FWD: WG: AW: oxytrue as housing

From: "Lindner, Bernd" <b.lindner@bluepoint-medical.com> (By way of info@viamed.co.uk)
To: SNIXON (Steve Nixon) <GoldMine User>
Date: Wed, 24 Jul 2013 13:16:13 +0100
Subject: **WG: AW: oxytrue as housing**

Here the shape 1 version.

ap_mobile-3.jpg
42K

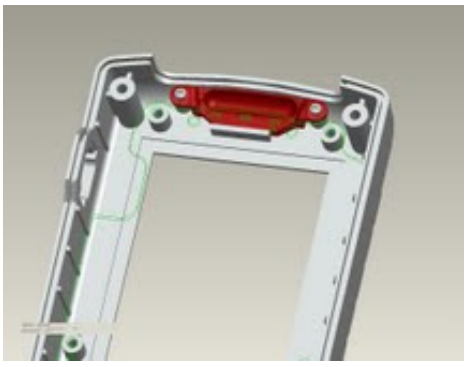
There is no space for the shape 2.
Here is the design based on shape 1.
ãã

We only want to add one additonal alarm light, which is shape 1.
